Permit of Authorization to Construct an On-Site Sewage Facility Permit Valid For One Year From Date Issued

Permit Number: 118837

808 SAGEBRUSH DR

Subject: RE: Permit # 118837

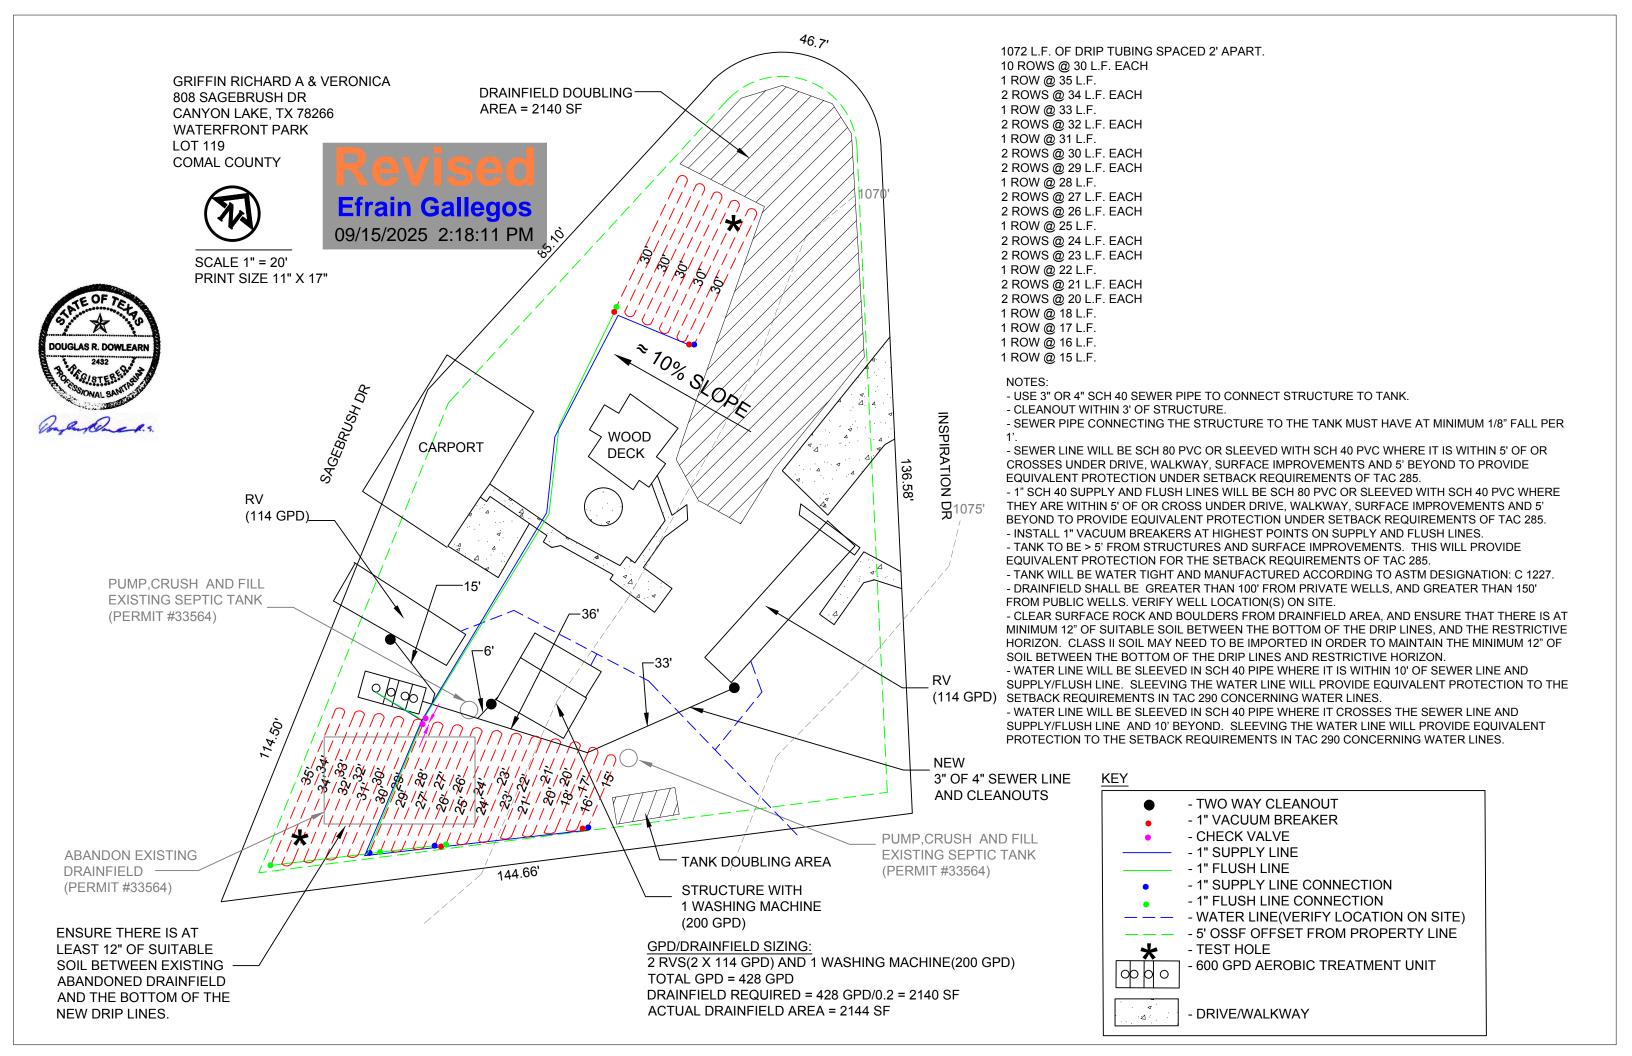
2. GPD for washing machine will have to show 200 GPD as per table III (Laundries)

Daily Waste Flow: 308 gpd

Application area required: 308/.2 = 1540 sq. ft

Application area utilized: 1544 sq. ft.

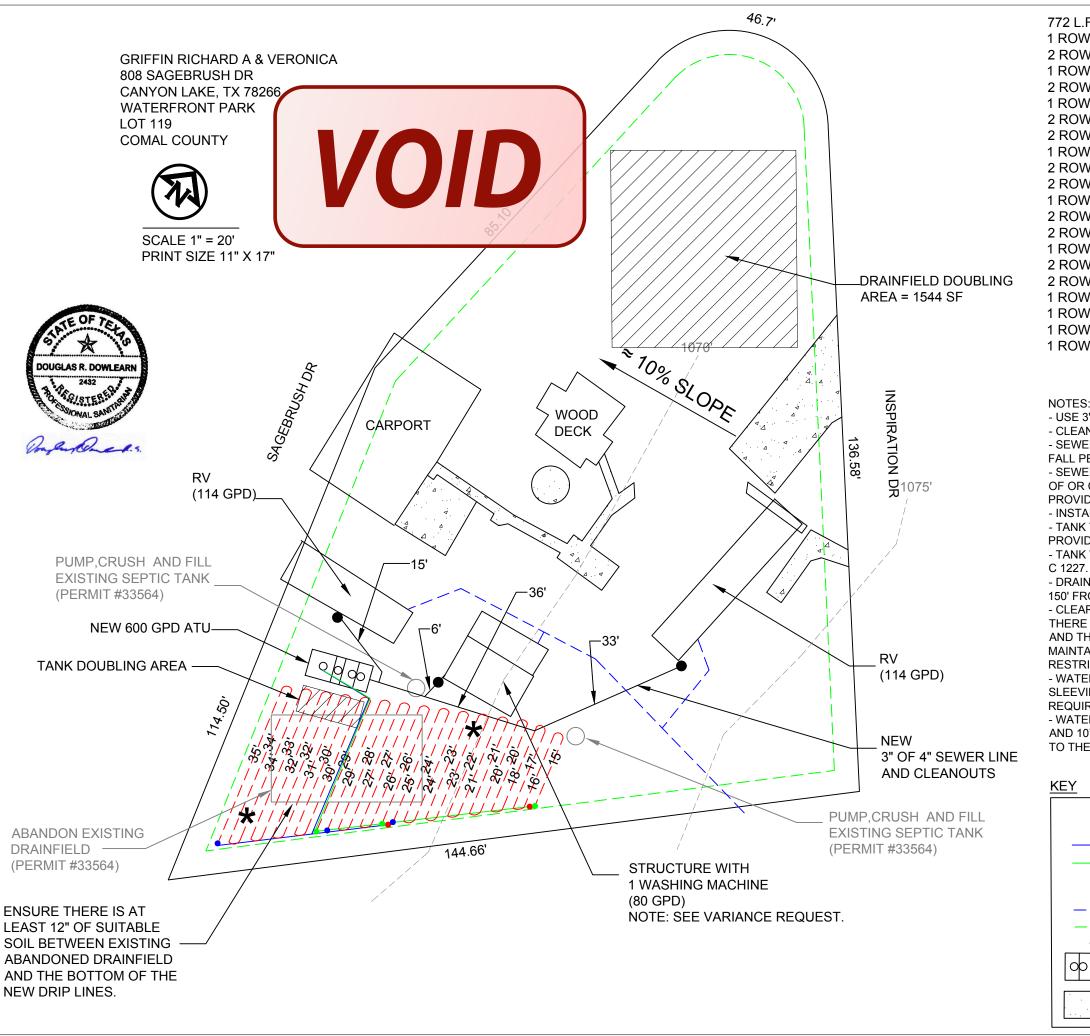
1. Tank doubling area cannot be in proposed drip area.
